Memorandum

Subject: Case File: LU 19-225732 SOWA Alamo Manhattan Blocks
Otak Responses to Land Use Review Comments dated November 21, 2019

Otak Project No.:19050.100

© 2019 HLR ARCHITECTS (INNER BLOCKS 42 & 45)

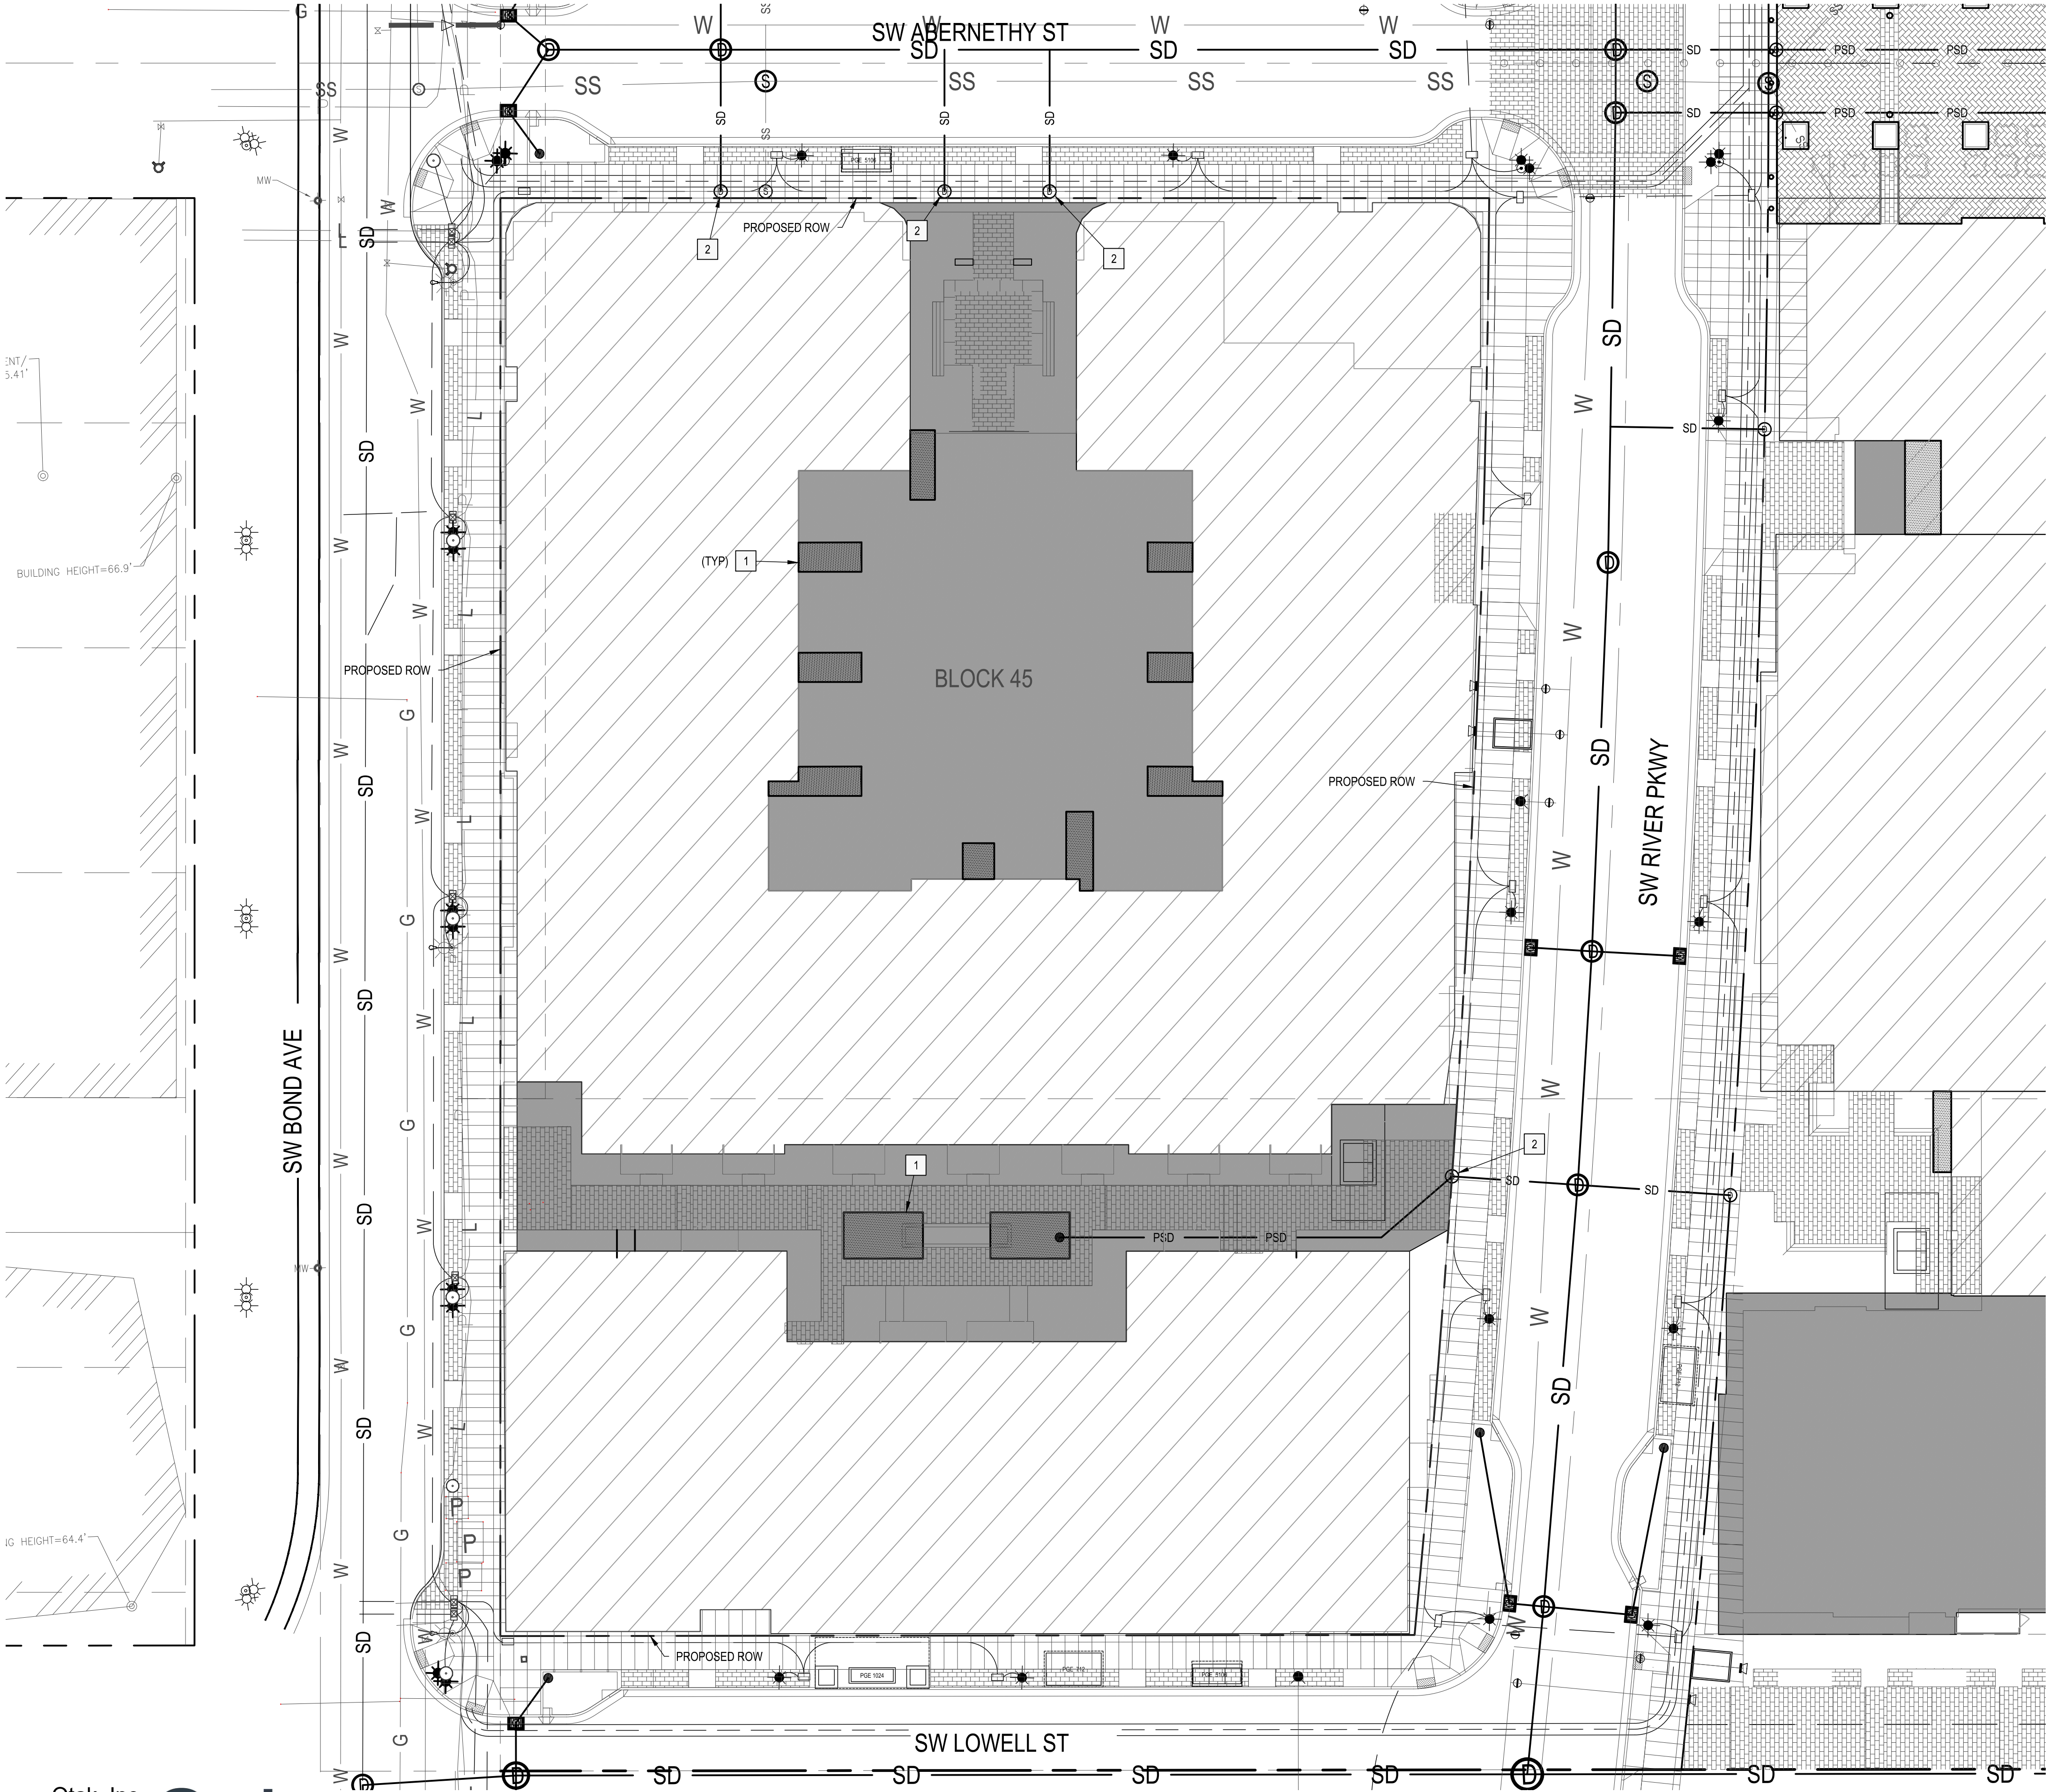
- 1)** *The stormwater report Figures 2.1 – 2.4 (exhibits C.124, C.125, C.126, C.127) as well as the Stormwater Plan figures (exhibits C. 116, C.117, C.118, C.119) provided in the design review package show ecoroof coverage for each building which is inconsistent with the stormwater report narrative. Ecoroofs are required on new buildings in the Central City Plan District (Portland City Code 33.510.243) and should be accounted for in the stormwater management plan.*

- 2) *Figures 2.1 – 2.4 of the stormwater report indicate the lined flow-through planters are managing non-ecorooft areas only and this is inconsistent with the narrative. Therefore, it is unclear if the applicant intends to only manage stormwater with lined flow-through planters or if stormwater will also be managed by ecoroofts. This information should be provided as changes to the size and location of the lined-planters could impact the design and layout of the site.*

A revised Design Review Conceptual Stormwater Management Plan will be resubmitted to show consistency between the report and the updated building/greenway plans. Note, as discussed with City BDS Planning staff, the project team is resubmitting the DR application under Title 33 code that went into effect on March 1, 2017. This eliminates the code requirement for ecoroofs that were provided in the original submittal. The reduction of ecoroofs on the project will impact the stormwater strategy in that we will utilize (and try to maximize) raised flow-through planters at intermediate roof levels and ground level for specific areas of non-ecoroof runoff. We will continue to use flow through planters at ground-level plaza and pedestrian access areas as the site design allows. We will incorporate stormfilter catch basins/vaults/downspouts (mechanical treatment) within each block for water quality treatment of areas not treated by vegetated facilities. These are typically at plaza areas that cannot accommodate the depth of required LIDA facilities (planters) due to conflicts with garage structure below plaza areas. Our proposed stormwater treatment design considers contributing

areas, collection locations, depth of facilities, outlet locations, and conveyance to storm laterals to the public storm system in adjacent streets.

We have attached preliminary exhibits for each Block that show stormwater treatment areas and facilities proposed for the four blocks. A revised Design Review Conceptual Stormwater Management Plan will be submitted to support the revised stormwater strategy for the project.

See response to 3.a.1 above. The amount of ecorooft will be reduced with the Design Review resubmittal. The use of conventional roofs on this project will increase the impervious area to managed on-site and a revised Design Review Conceptual Stormwater Management Plan will show the use of raised flow-through planters, ground level lined flow-through planters, and stormfilters to meet the stormwater treatment requirements on each block. The design will utilize raised flow-through planters at intermediate roof levels and ground levels to treat specific areas of impervious roof runoff.
